Organic Gold (Marketing) Ltd. Composting Plant

REPLY TO REQUEST FOR ADDITIONAL INFORMATION

Client	Organic Gold (Marketing) Ltd.					
Project Title	Organic Gold Compost Facility					
Document Title	Reply to EPA Article 12 Requests					
Document No.	MDE0202Rp0007A01					
This Document Comprises	DCS	TOC	Text	List of Tables	List of Figures	No. of Appendices
	1	3	11	0	0	3

PROPOSED SITE LAYOUT PLAN

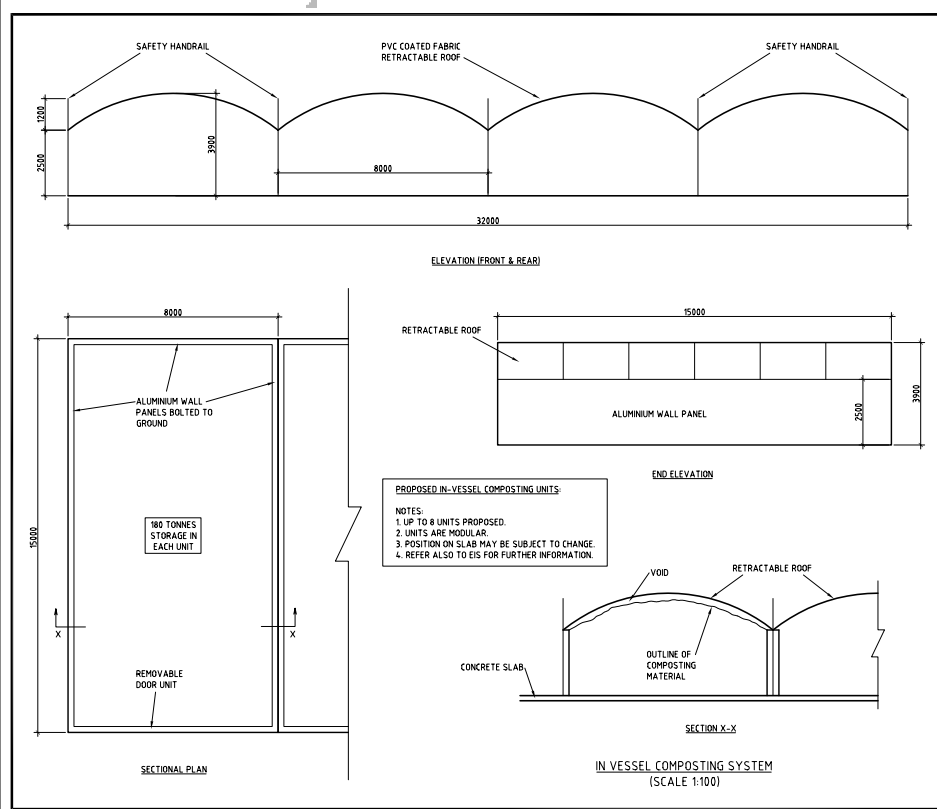
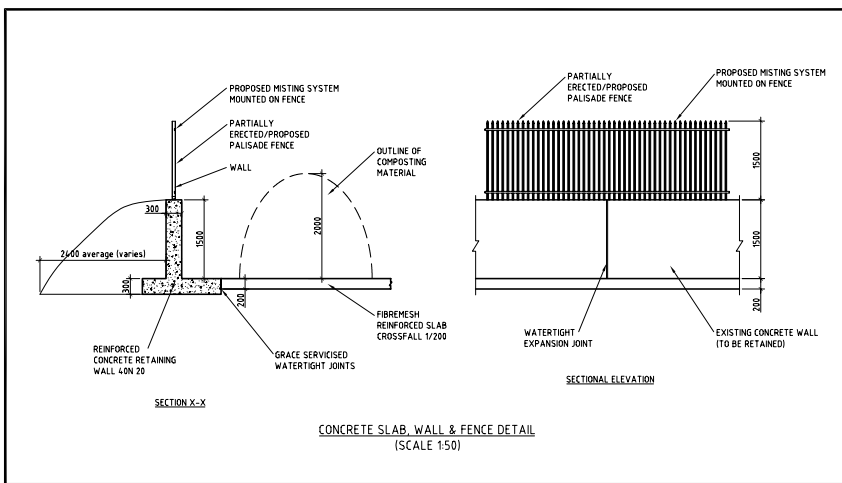
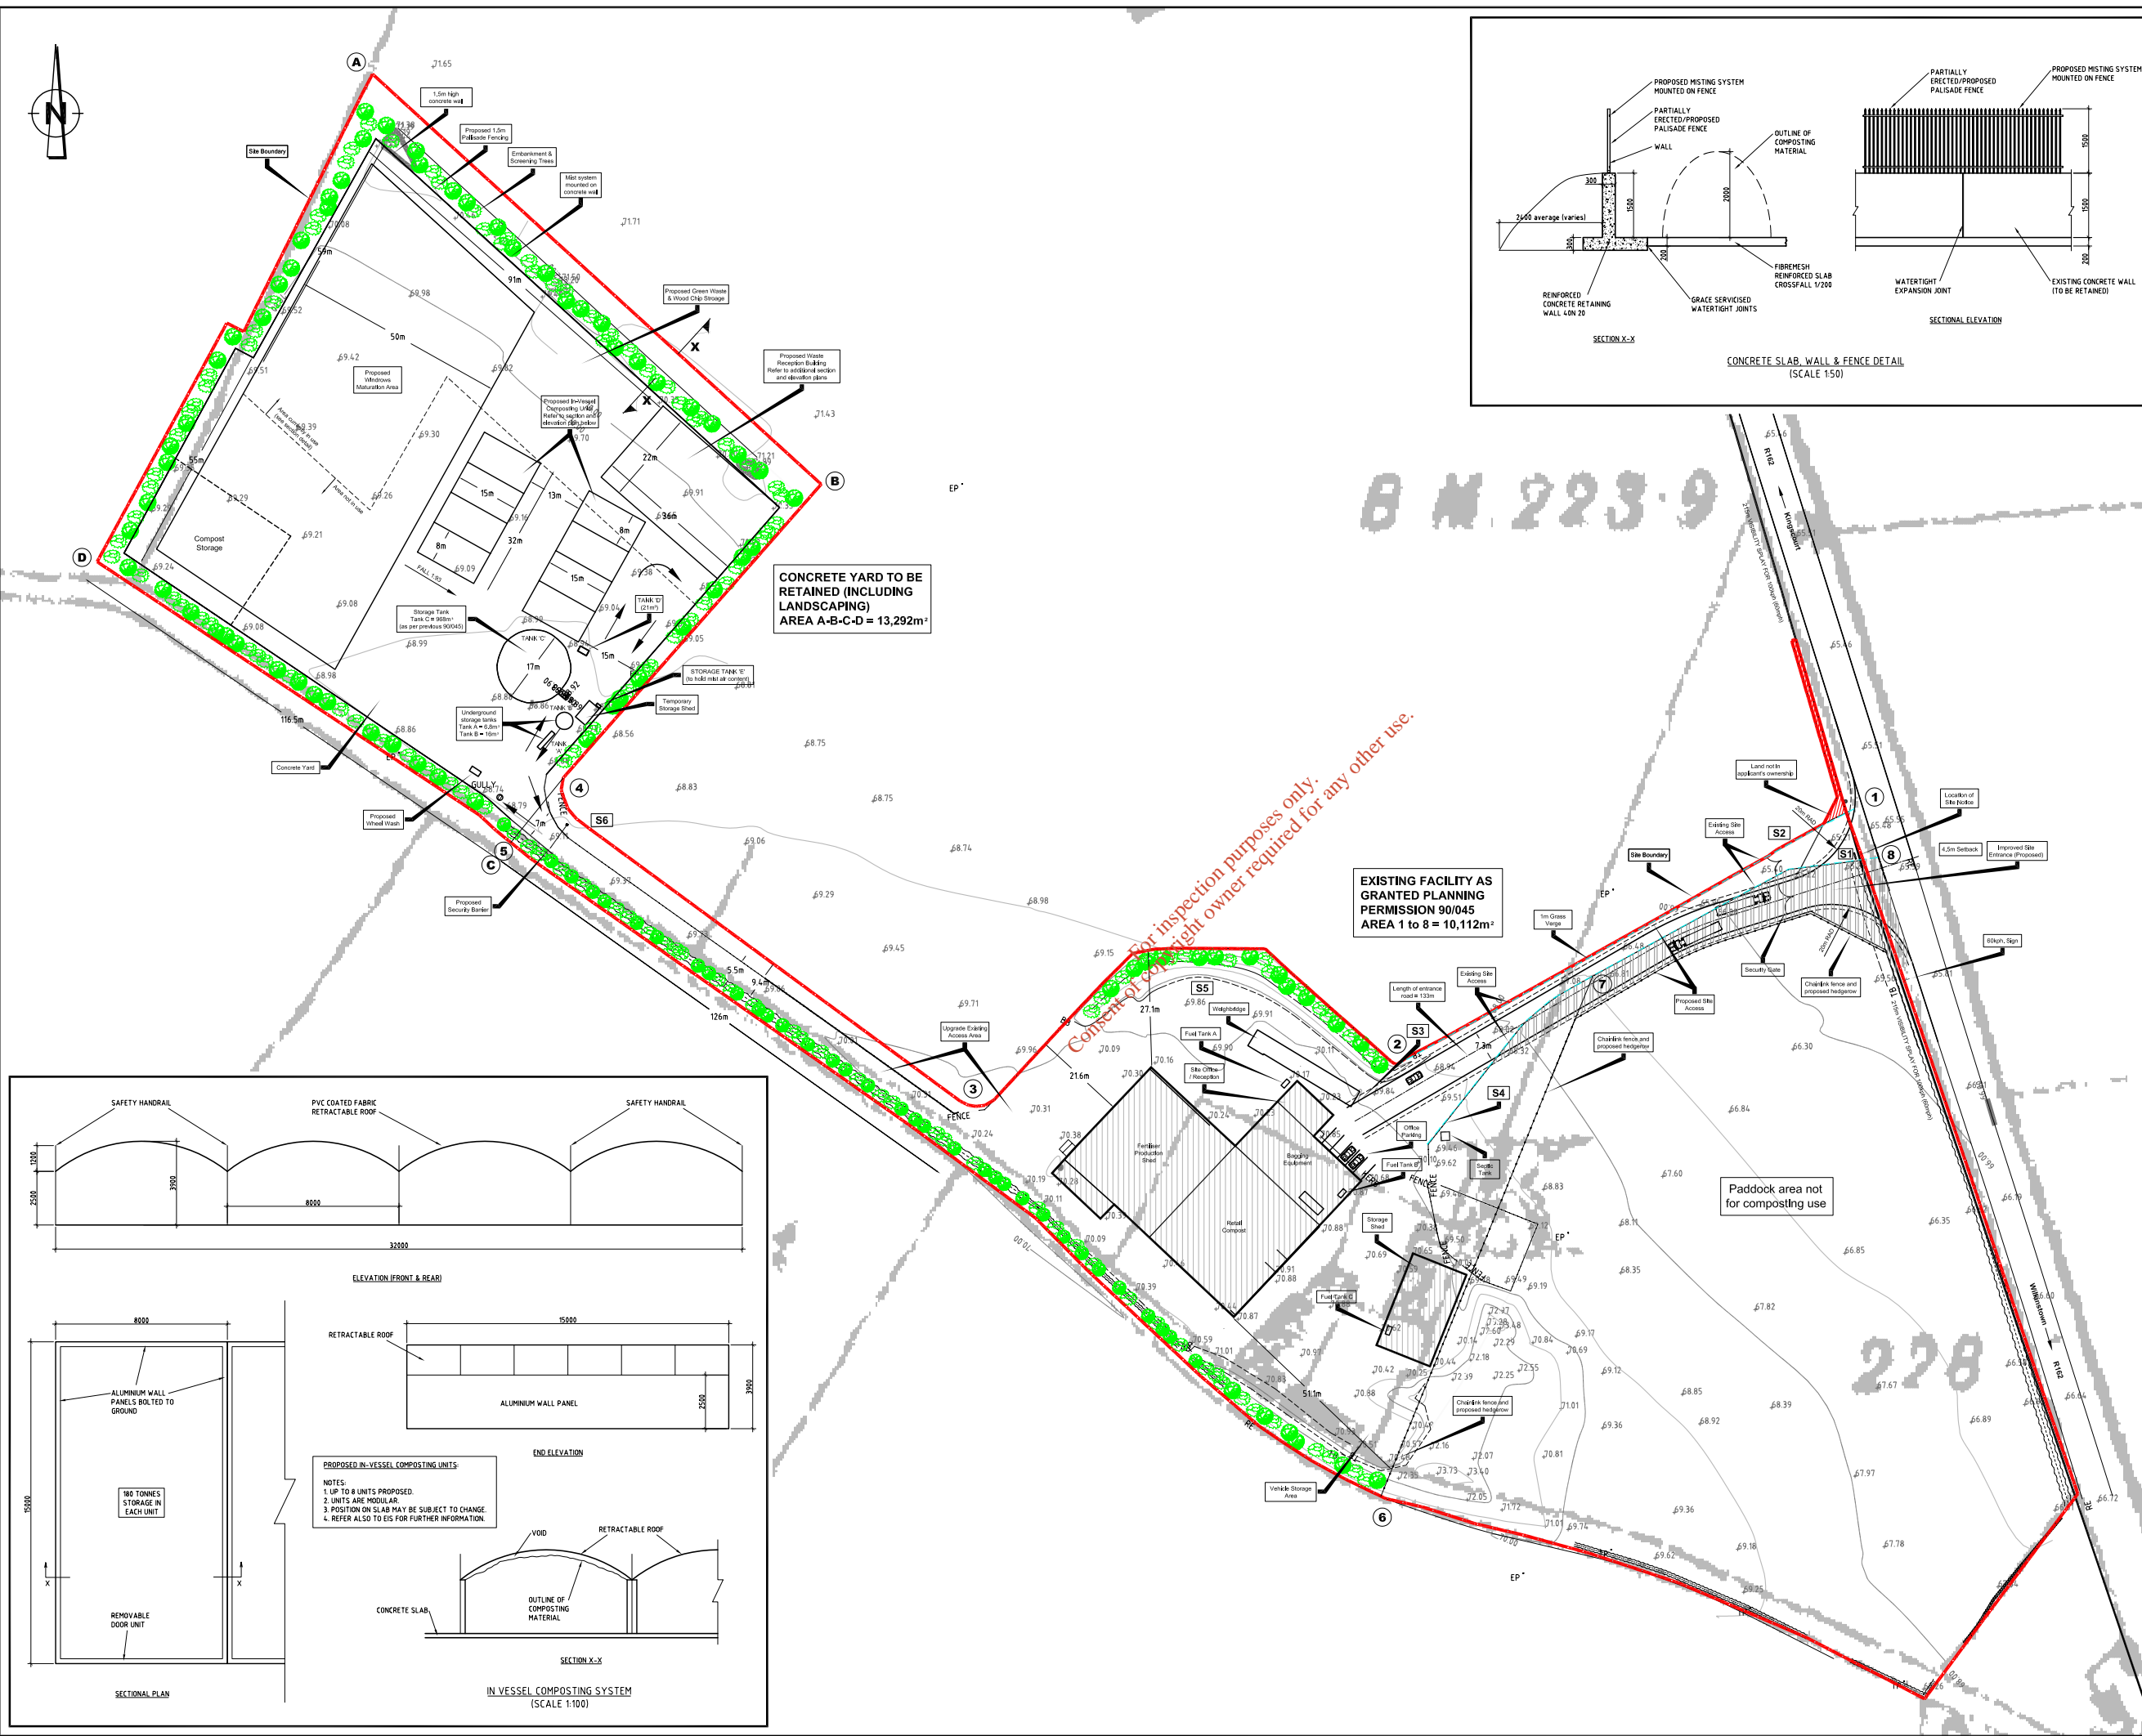
1. ***Submit a revised site layout map incorporating the location of the water tank on the concrete composting slab and indicate its purpose. Please note the tank in question is not Tank C but a tank observed adjacent to the temporary storage shed during the site notice inspection on the 19/05/05.***

A revised Site Layout Drawing **DG0002 A06** is attached in **Appendix A** and indicates the location of the additional storage Tank E. Storage Tank E is located beside the temporary storage shed and acts as a storage tank for the mix that is used in the Mist Air System. This tank is fully enclosed. A material safety data sheet for this mix is attached in Appendix 3 of Volume 2 of the EIS.

SURFACE WATER DRAINAGE

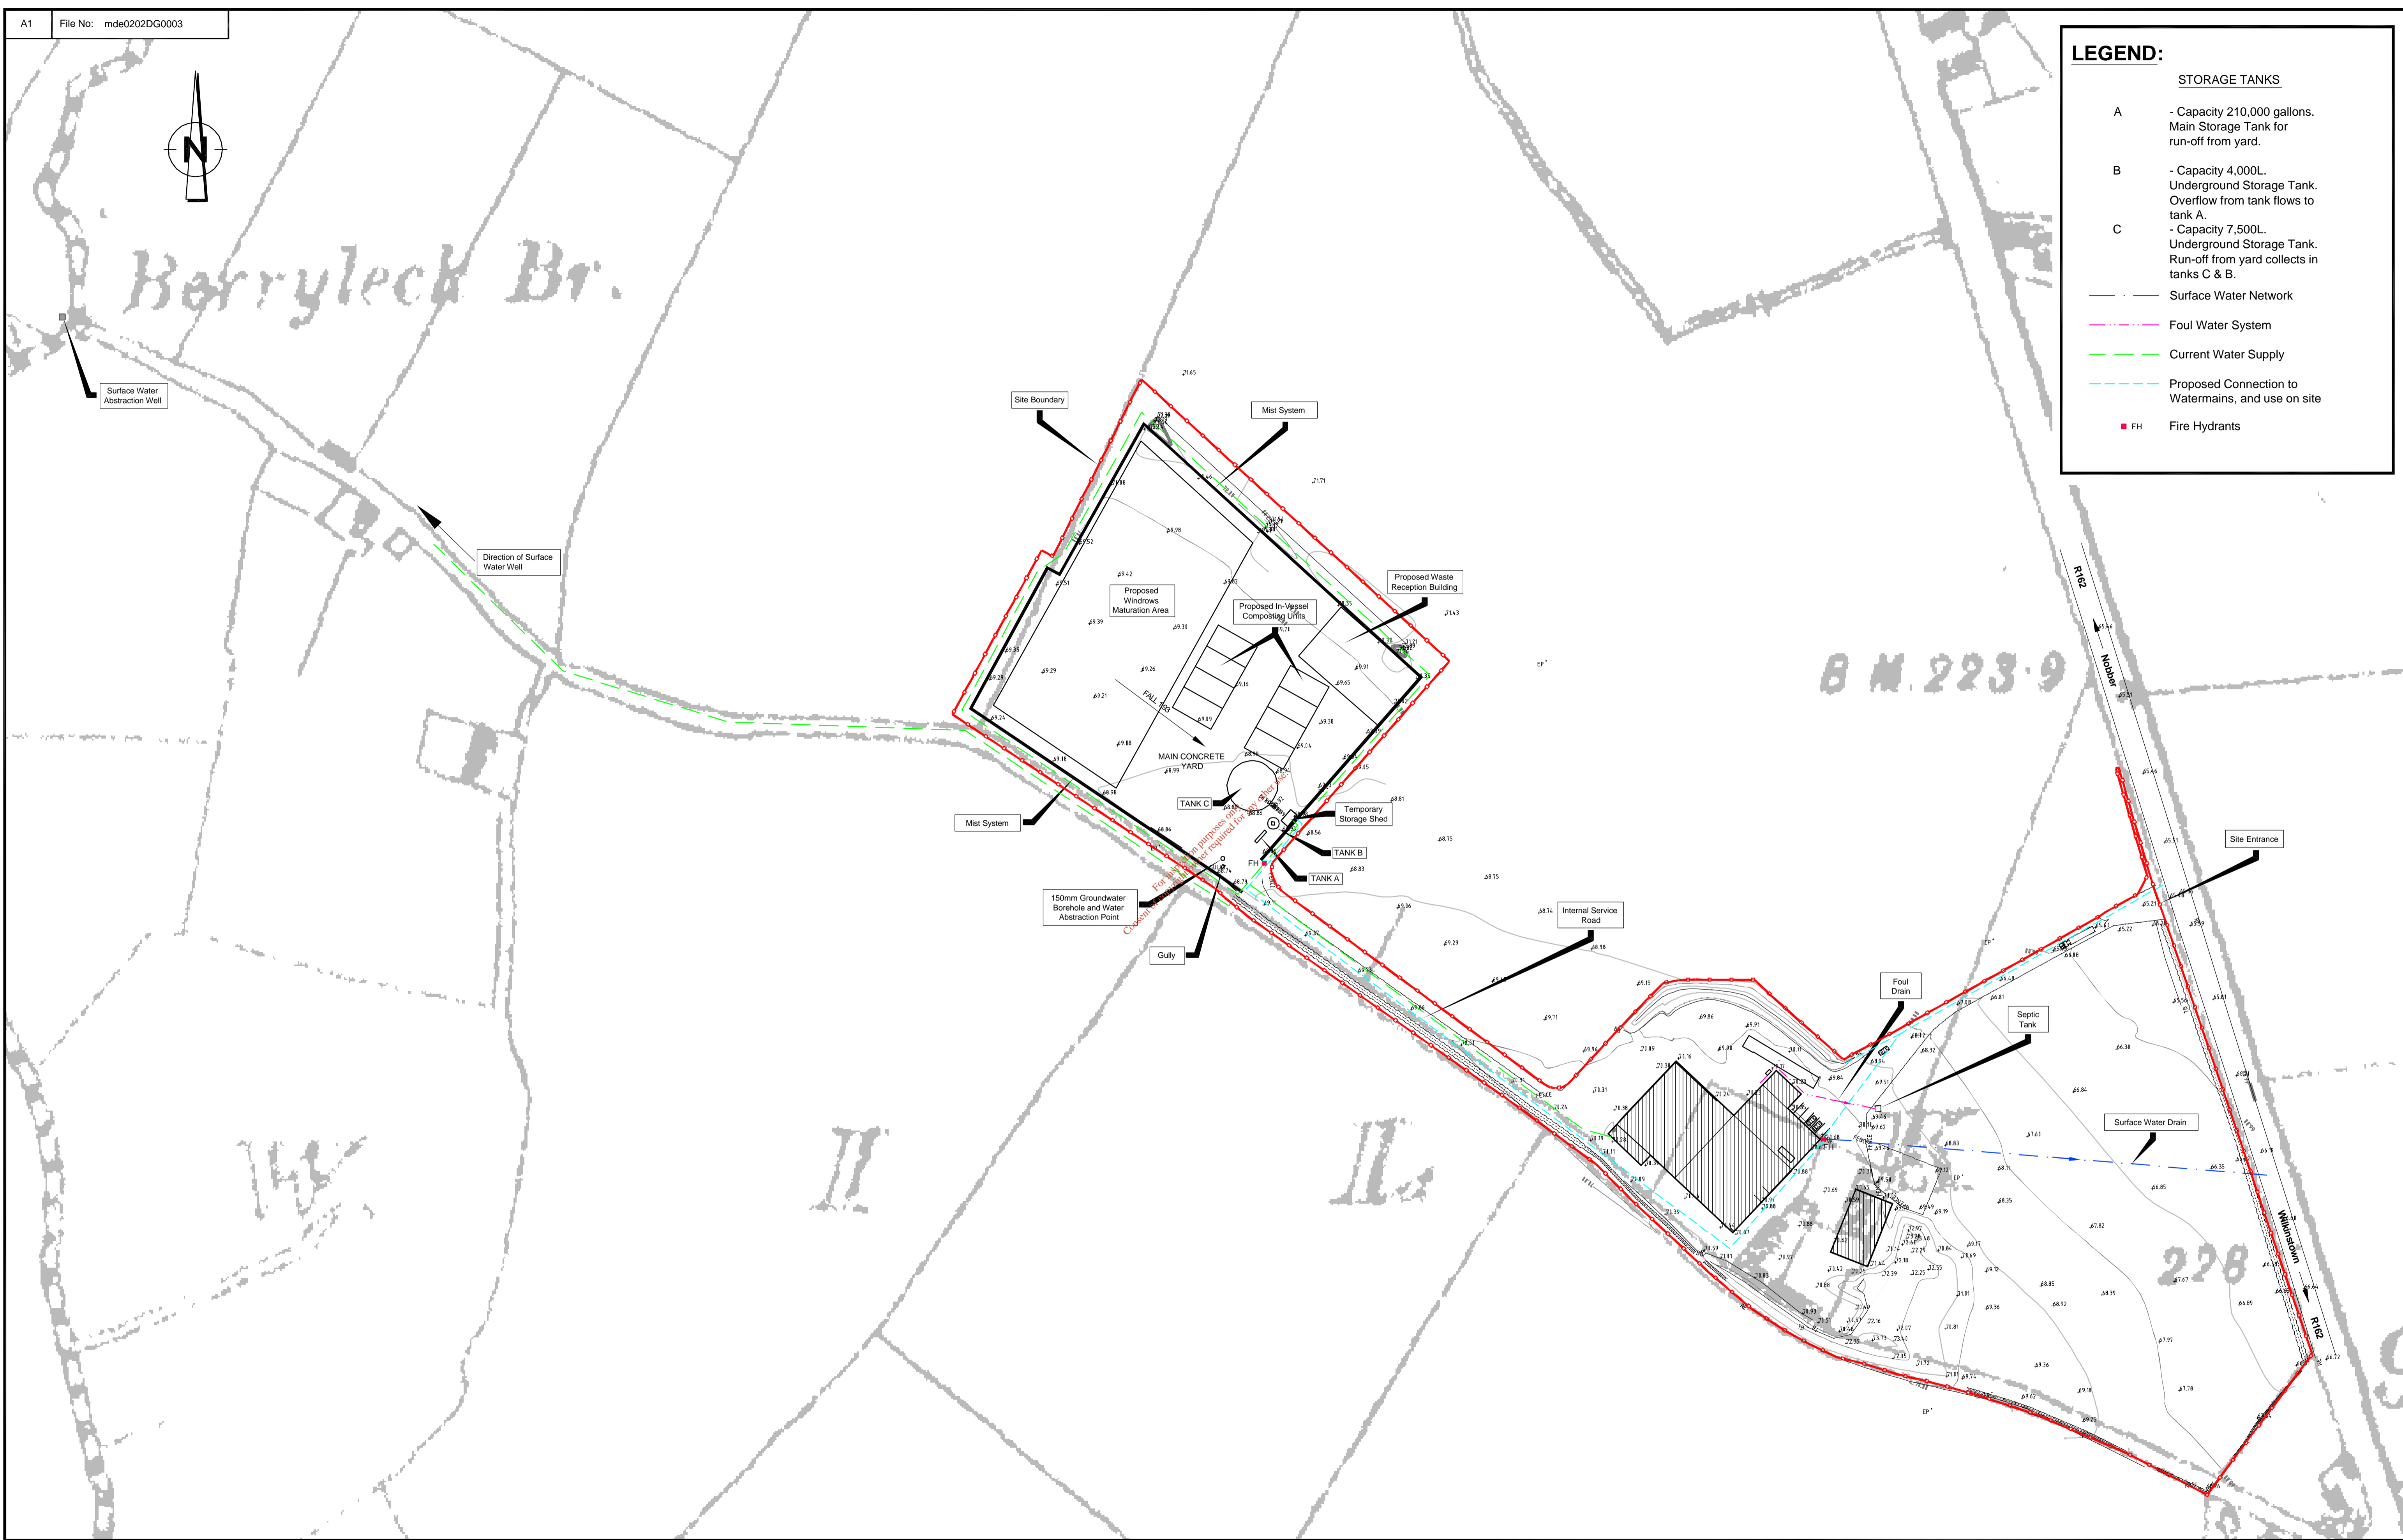
5. Identify on a suitably scaled map the location of the well and provide details of mitigation measures to protect the well from contamination.

The location of the surface water abstraction well can be seen on the Surface Water Drainage Drawing **DG0007 A02** in **Appendix C**. It is located 330 metres from the South Western boundary of the composting slab. This well will not be at any risk of contamination from the activities from the proposed facility due its location up-gradient from the waste treatment processes and due to the fact that the facility is completely bunded by the concreted slab and there will be no impact on ground or surface water in the area surrounding the facility.

The groundwater abstraction well located on the composting slab is currently not in use and will not be used for future activities. This well will be completely sealed by an appropriately qualified engineer before operations commence at the proposed facility and details of which, will be submitted to the EPA accordingly.
